From: Joyce Christie
Sent: 06 May 2025 15:30
To: Shona King
Cc: DC Support; Nathanael Stock
Subject: 25/00527/DISC North Arms

Discharge of Condition 9 (details of structural opening) of 24/01880/LB

Extract P11D

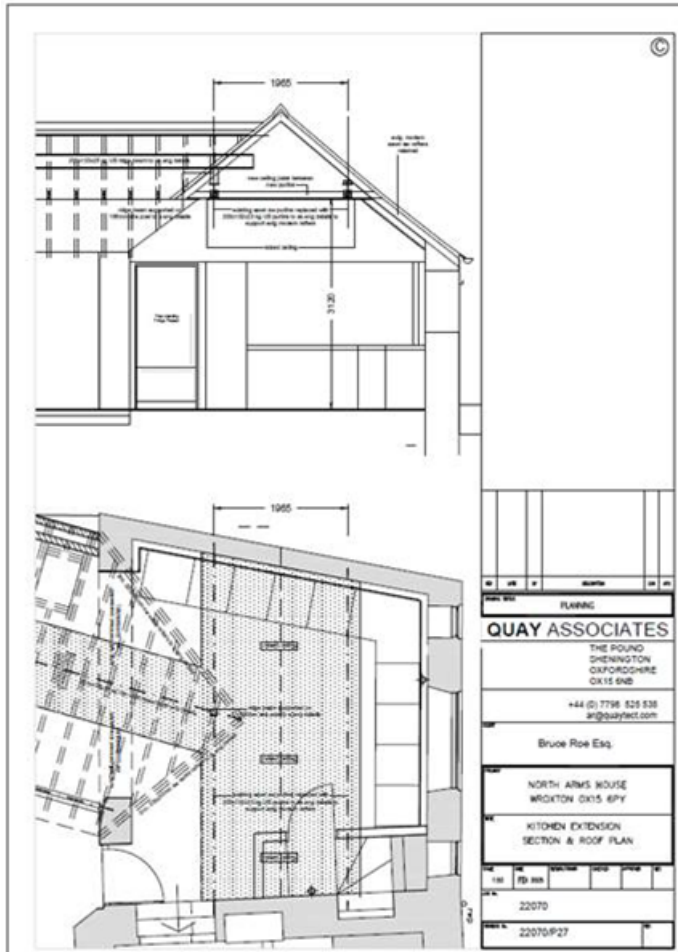
P11D shows the whole floor plan. Drawings 12C and 13B were also submitted but these are not relevant to Condition 9 of 24/01880/LB.

P27
 Please ask for a bit more information on Drg P27 to show the existing floor slab junction with the new floor slab and how the ceiling finishes between the existing and proposed relate to one another. Please also confirm how the new steel that is to be inserted to support the ridge of the new roof will be embedded in the masonry. Can they supply further detail on the junction between the extension roof and the stone pier between the large opening and the door. Please note Drg P11D and P27 are different as P11 doesn't show a door and appears to show a wider opening?

Drawing P11D continues to relate to the original approval ref.: **22/03307/F & 22/03308/LB** in order to highlight the variations, as now requested. Drawing P27 relates to the subsequently Consented kitchen extension ref.: **24/01879/F & 24/01880/LB**

Response:
Floor – agreed.
Purlin steels – agreed.
P11D and P27 – noted.
